Australian Energy Market Commission

**Rule Determination**

**National Electricity Amendment (Minor  
Change to Technical Requirement for  
Generators) Rule 2008**

07 August 2008

**Figure 1: Frequency ranges and time ranges for the *minimum access standard***

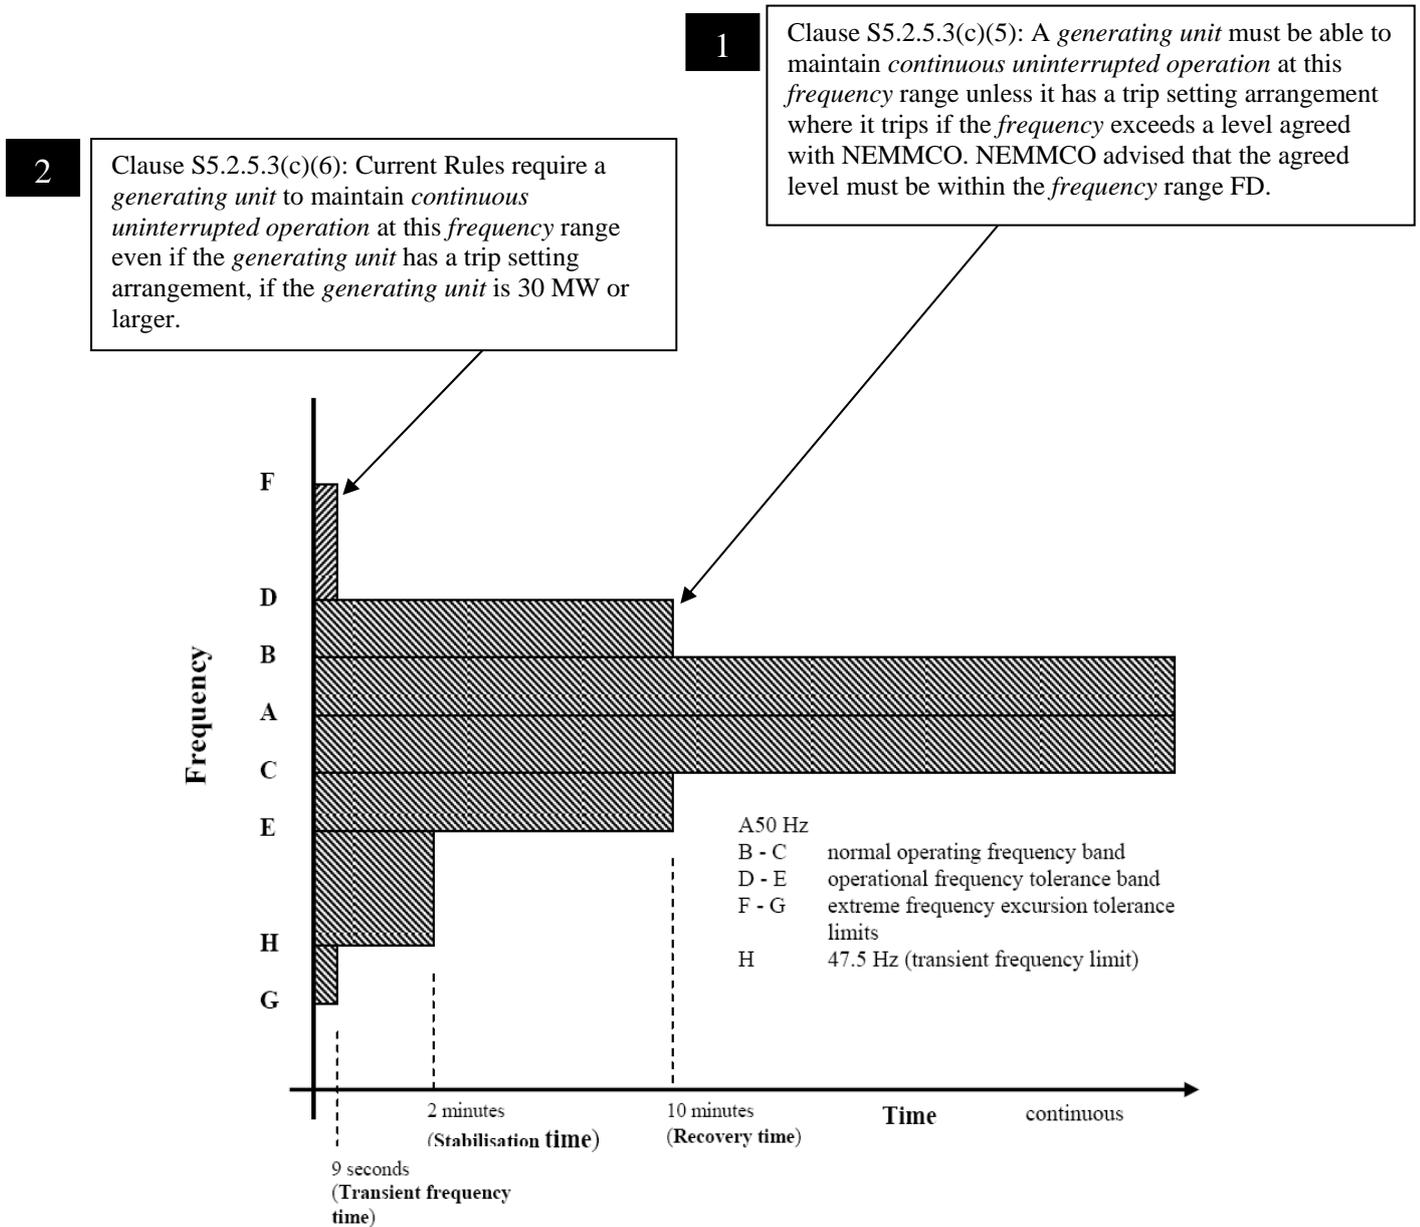
Box 1: During a *frequency* disturbance event where the *frequency* falls within the range FD, a *generating unit* with a trip setting arrangement would have tripped (required by clause S5.2.5.3(c)(5)).

Box 2: However, clause S5.2.5.3(c)(6) requires the *generating unit* (if it is 30 MW or larger) to maintain *continuous uninterrupted operation* at *frequency* band FD.

One clause of the Rules requires the *generating unit* to trip whilst the other clause requires the *generating unit* to maintain *continuous uninterrupted operation*. This is physically impossible.

During a *frequency* disturbance event where the *frequency* falls within the band FD (see Figure 1), clause S5.2.5.3(c)(5) would require a *generating unit* (within a *generating system* that has a trip setting arrangement) to trip. On the other hand, clause S5.2.5.3(c)(6) requires the *generating unit* (if it is in a *generating system* that is 30 MW or larger) to maintain a continuous *uninterrupted operation* at *frequency range FD*.

The Commission considers the impossibility, of satisfying both clauses S5.2.5.3(c)(5) and S5.2.5.3(c)(6) at the same time, is due to the word “or” (instead of the intended “and”) in the current clause S5.2.5.3(c)(6)(i) of the Rules.

The Commission considers rectifying Drafting Error II would allow generators to meet the requirements in the Rules that is otherwise impossible to meet. This reduces the barrier to entry and contributes to achieving the NEO, especially for generators who are not able to meet clauses S5.2.5.3(c)(5) and S5.2.5.3(c)(6) concurrently under the current Rules.

The Commission considers rectifying Drafting Error II would clarify NEMMCO’s intention that only generators with combined capacity at 30 MW or more, and<sup>4</sup> that do not have a *protection system*, would be required to maintain *continuous uninterrupted operation* at *frequency range FD* (of Figure 1) for at least the transient frequency time<sup>5</sup>. This would reduce the barrier to entry for generating facilities by promoting certainty in the regulatory environment. This is likely to contribute towards achieving the NEO.
